## SERVICE INFORMATION NO. SI 40-041

EASA AD No.: 2006 – 0295-E for  
Engine – Contamination of the Engine Fuel System – Inspection  
ATA-Code: 72

## NO. MSB-40-048/2

## WI-MSB-40.048/2

**FUEL PRESSURE SENSOR**  
(VIEW LOOKING UP)

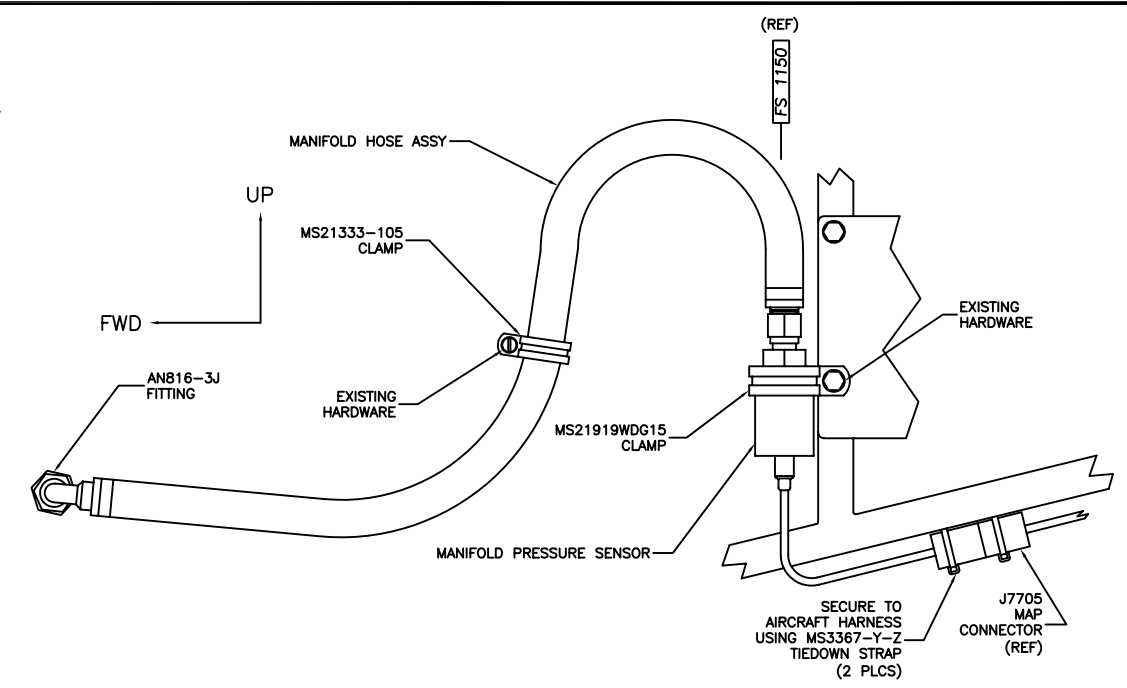
1	Install flow divider.
2	Connect stainless steel fuel lines, inlet fuel hose and vent hose to flow divider.
3	Reinstall 90° inlet fitting p/n D41-7306-00-31 with new O-Ring (P/N 951789) in servo.
4	Install new reduced flow 90° fitting p/n 233-10010-01 with new O-Ring (P/N MS29512-04) in servo.
5	Install fuel injection servo (refer to AMM Section 73-00).
